AMENDMENT REQUIRED THIS :

REV.	DATE	DESCRIPTION	BY	CHK
1	7/27/10	AMENDMENT NO. 1		
FOSDICK & HILKER CONSULTING ENGINEERS 308 THE SPOT, SUITE 50 TULSA, OK 74106-1540 TEL: (918) 438-1100 FAX: (918) 438-1101 WWW.FHENGINEERS.COM				
DOYON UTILITIES 1000 West 10th Avenue, Suite 200 Anchorage, Alaska 99501 (907) 562-1000 (907) 562-1001			DATE	REVISION
PROJECT NO. 101255, 101256, 101257 FORT WAINWRIGHT, AK. UTILITY MOUNTING			10/12/10	1. NTS
UTILITY SERVICE EXTENSION TO AIRCRAFT PARTS STORAGE			10/12/10	2. OK
DU PROJECT NO. 101255, 101256, 101257			10/12/10	3. JT
Drawing No.			PC-08

Attachment A-2
DU Furnished WDS Piping Materials
Aircraft Parts Storage - FTW 336A

Attn: Jason Bergman
RE: Utility Service Extension to Aircraft Parts Storage - FTW 336A

DETAIL 4 PRESSURE TRANSMITTER

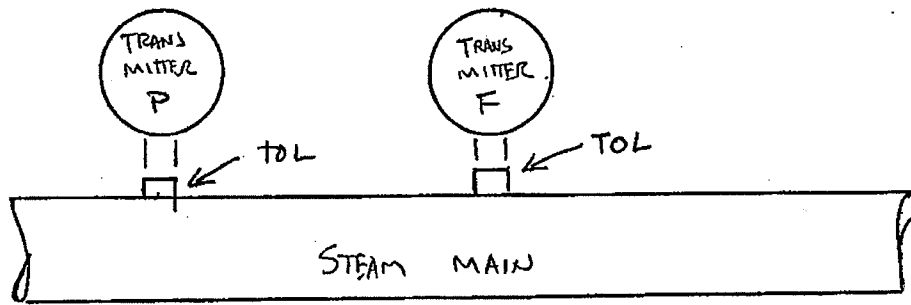
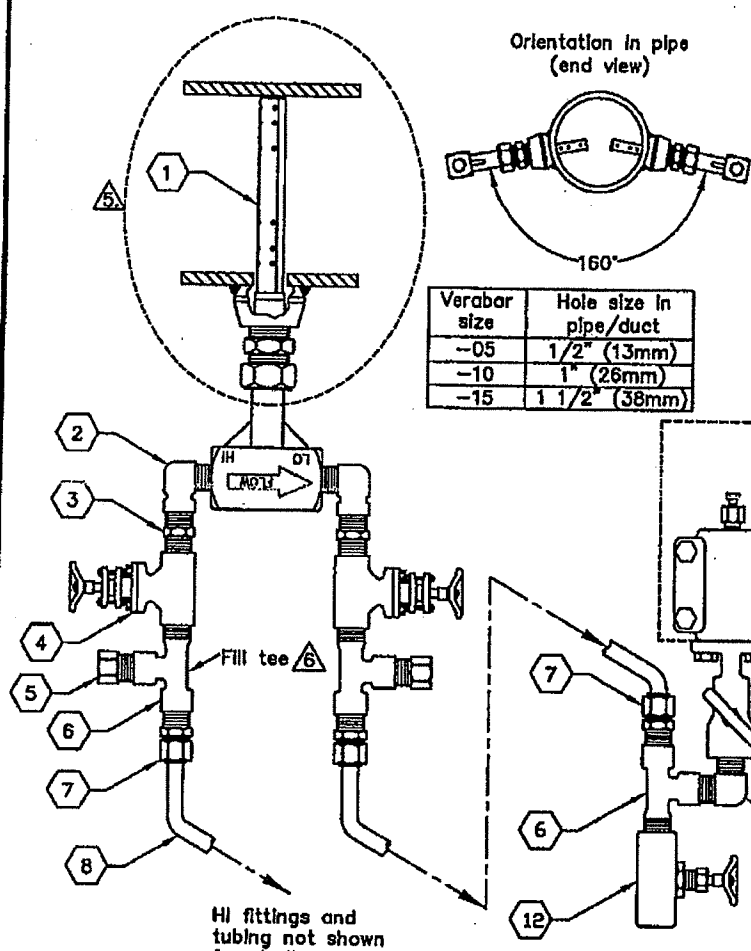
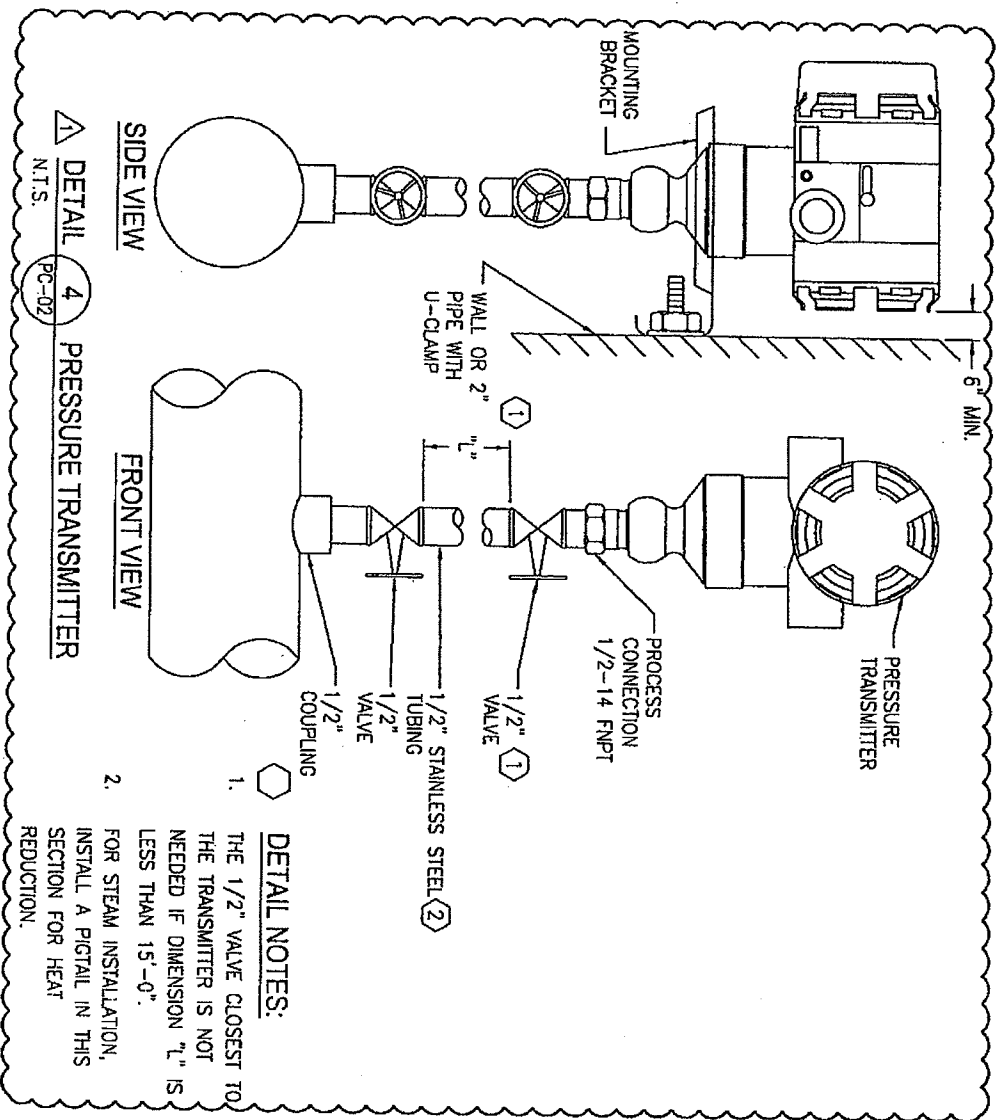
We planned to do this:

AND THIS:

CHANGE PROPOSAL COVERS CIRCLED ITEMS

DETAIL NOTES:

THE 1/2" VALVE CLOSEST TO THE TRANSMITTER IS NOT NEEDED IF DIMENSION "L" IS LESS THAN 15'-0".

FOR STEAM INSTALLATION, INSTALL A PIGTAIL IN THIS SECTION FOR HEAT REDUCTION.
